## Avon Parks – Burnett Park and Winton Meadows Park Addendum 02

DATE: Friday, February 20, 2026

PROJECT NAME: **Burnette Park and Winton Meadows Park**

The extent of this addendum is as follows:

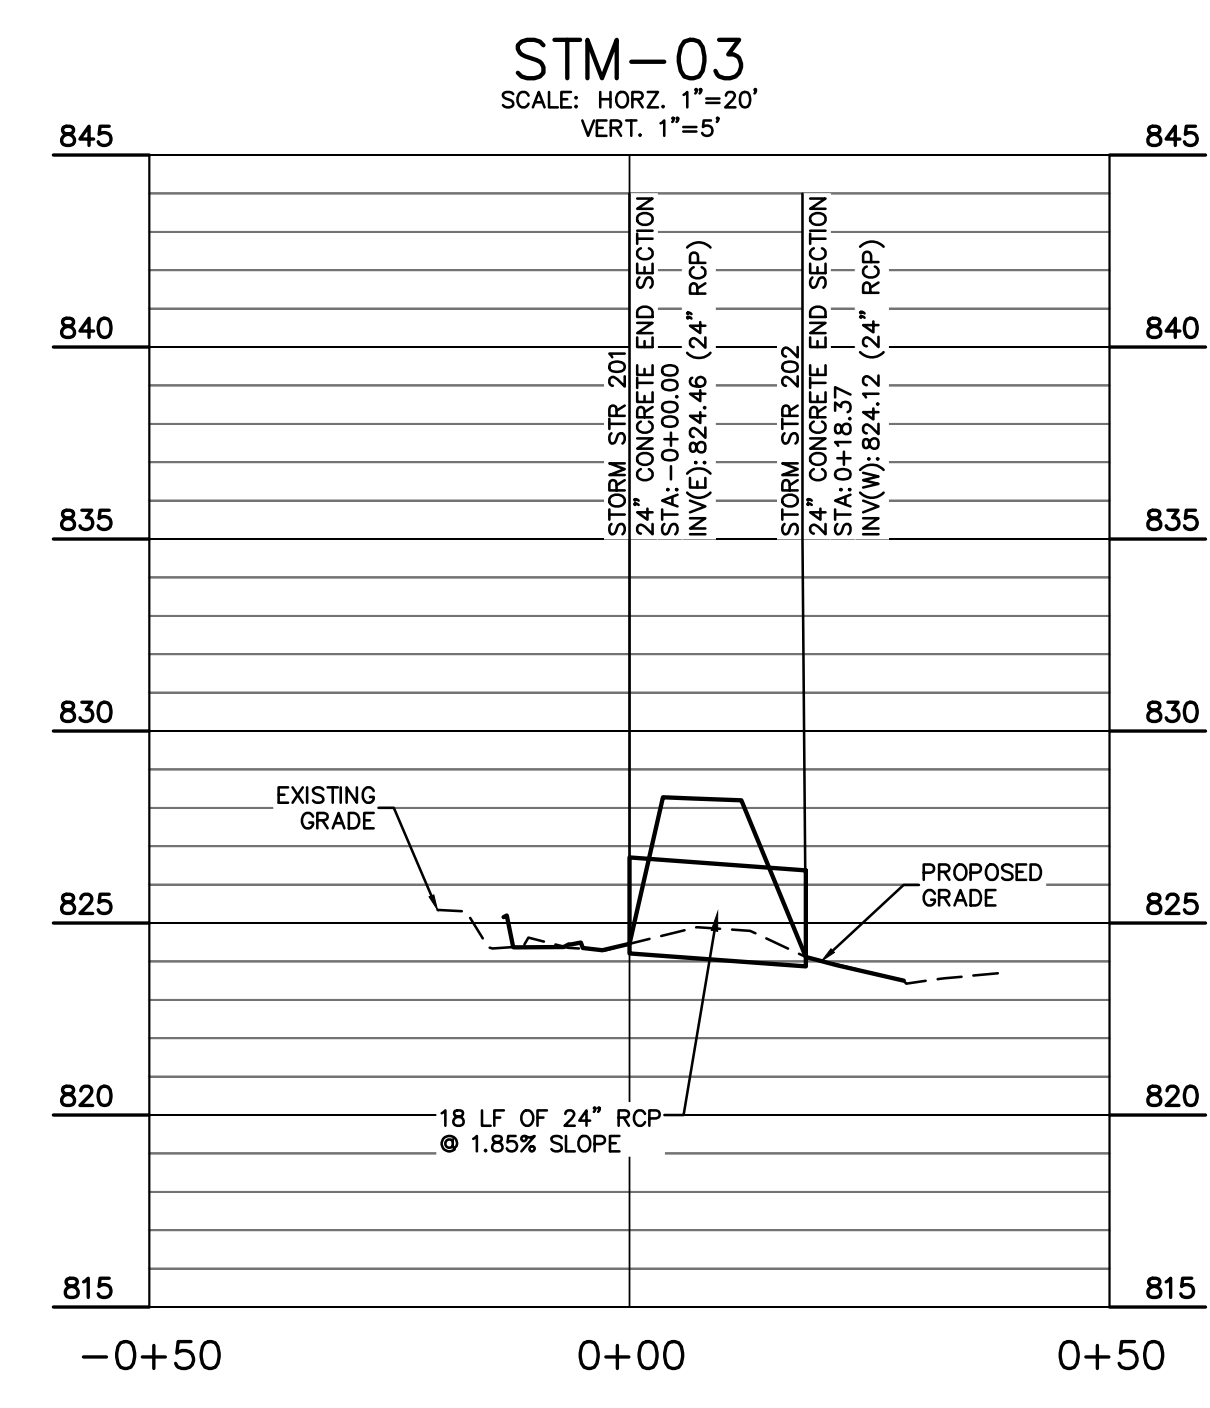
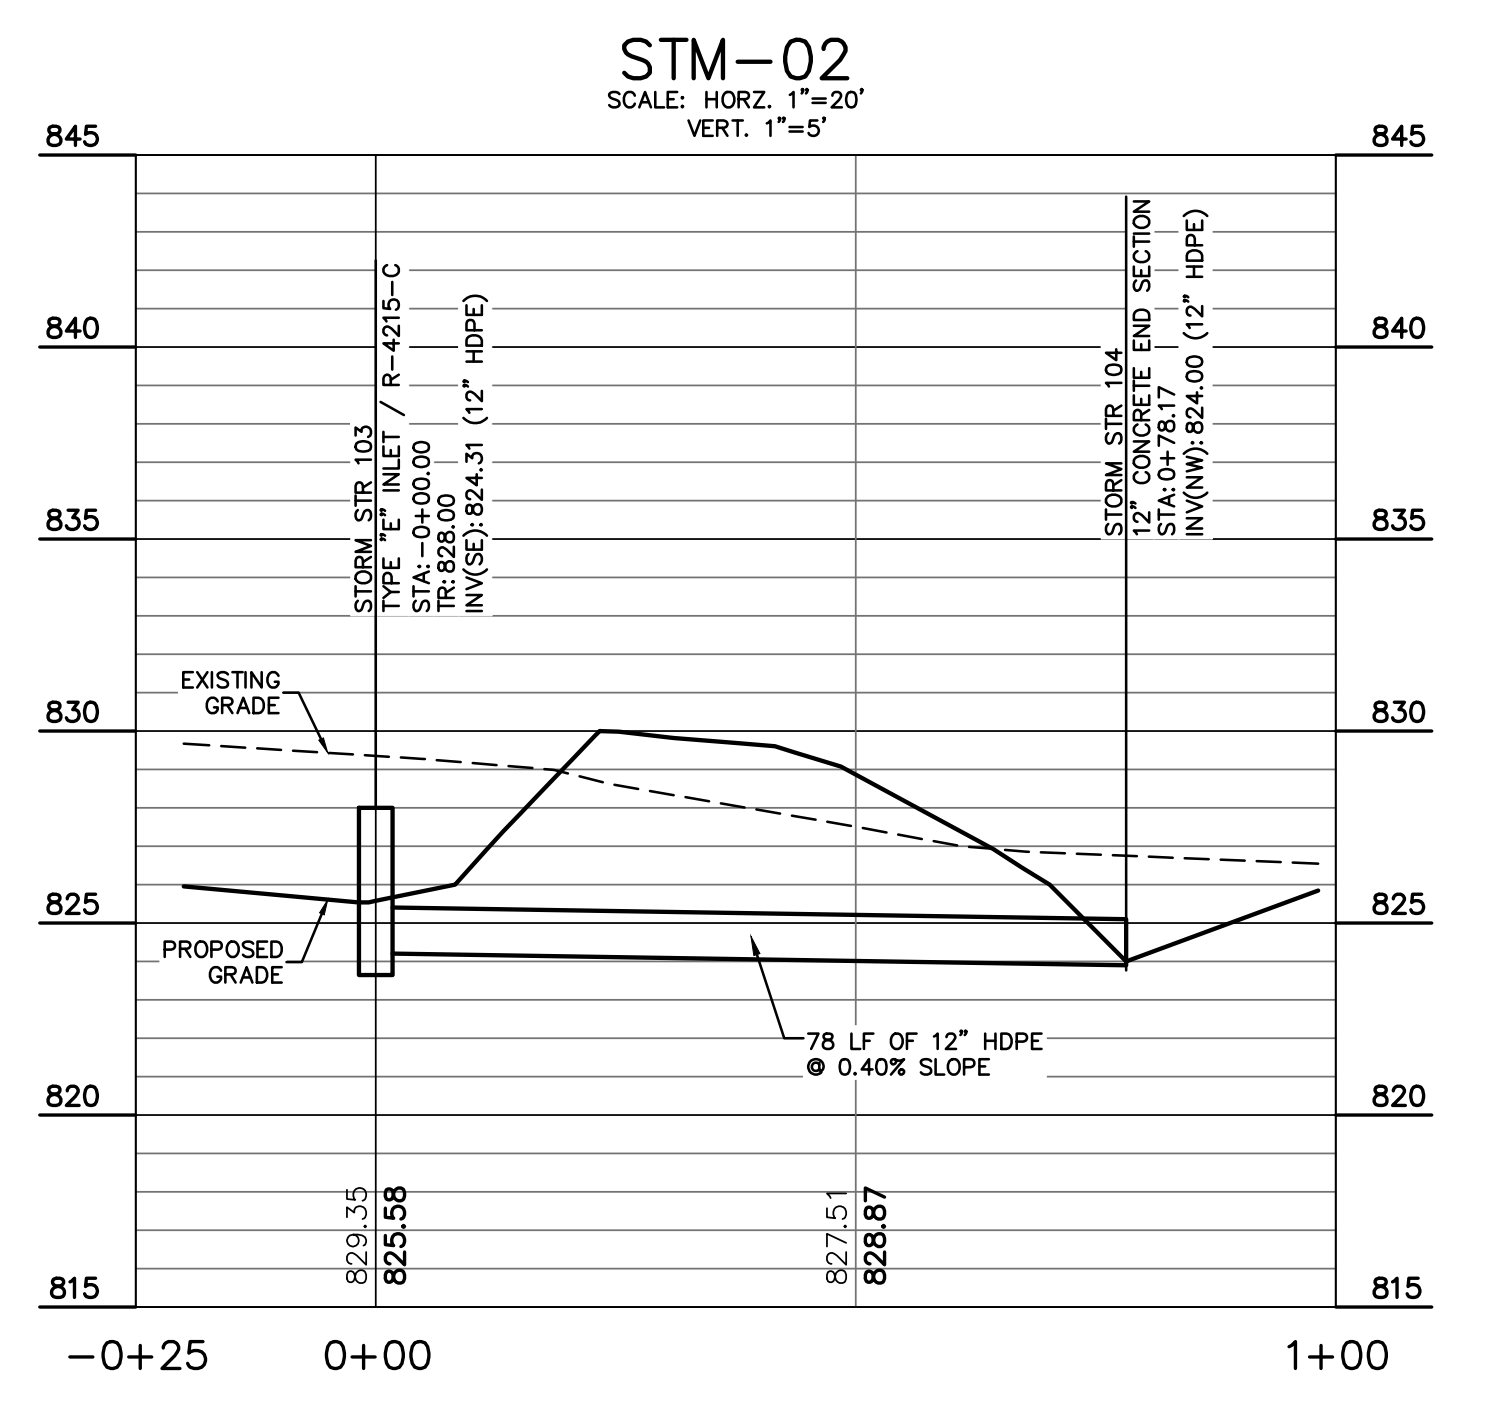
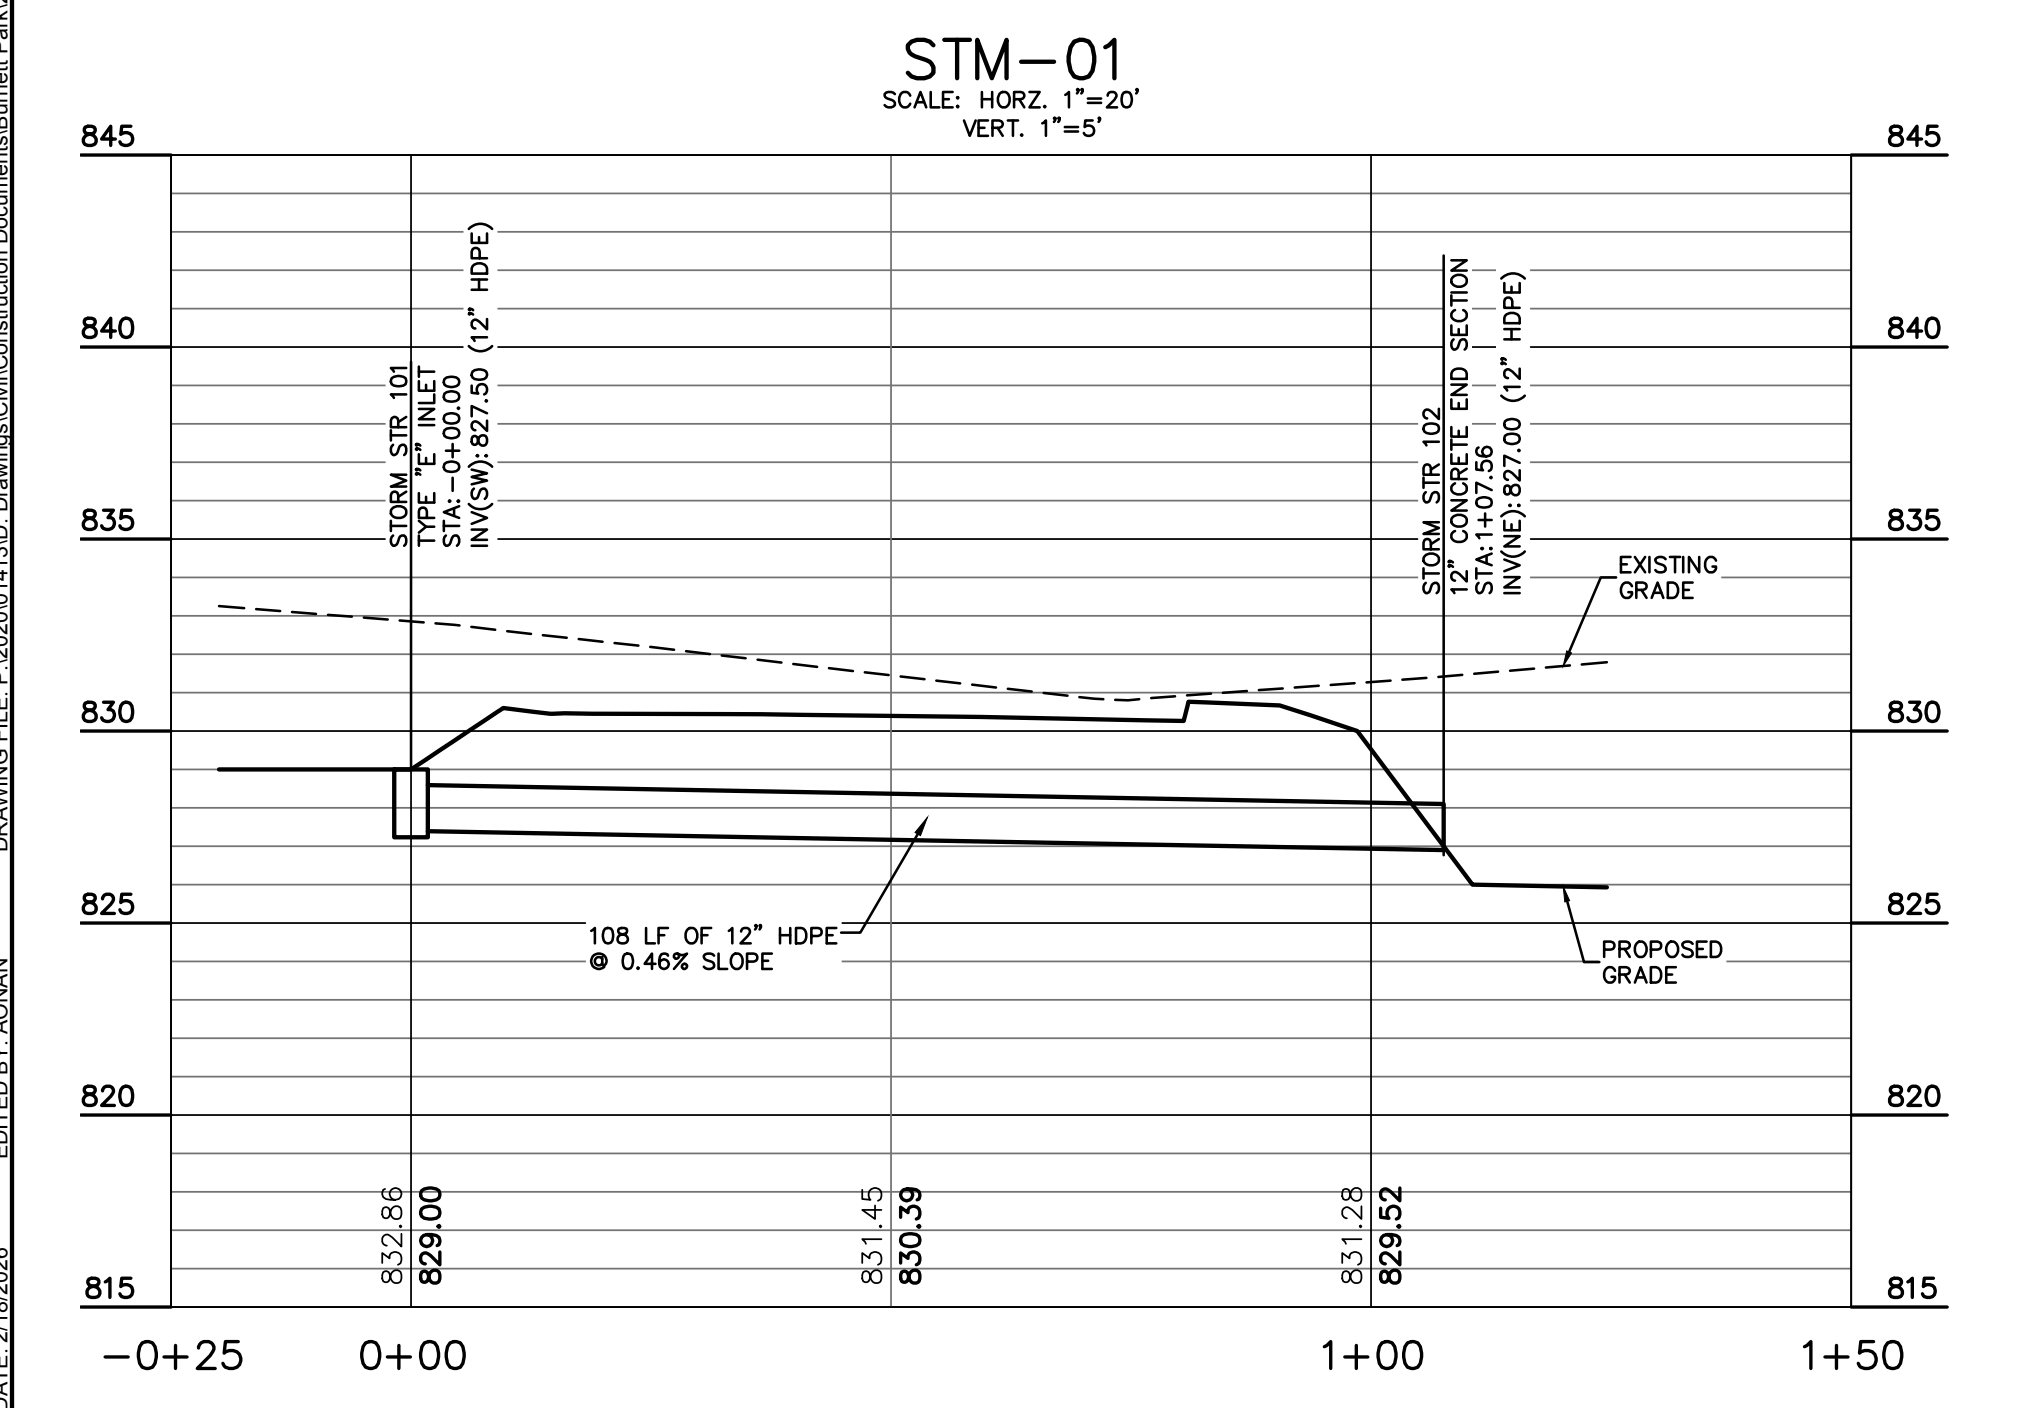
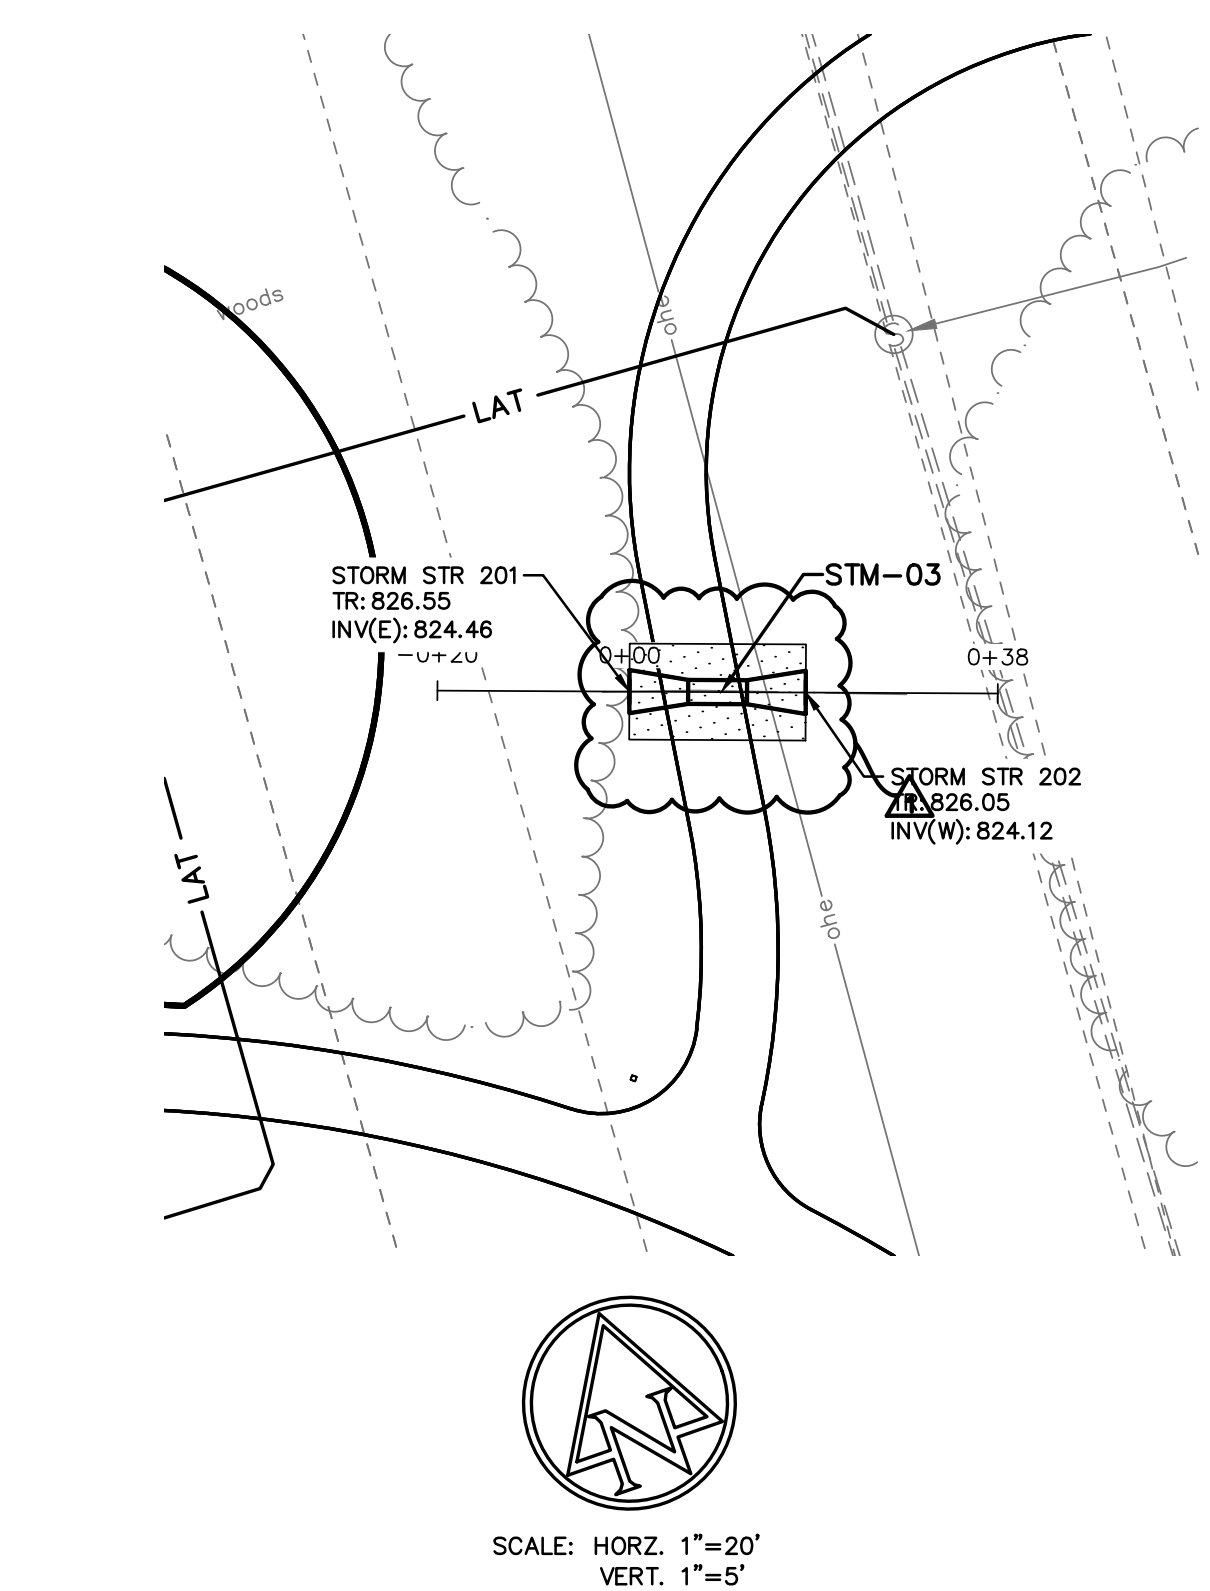
- a) STR 101 revised to inlet.
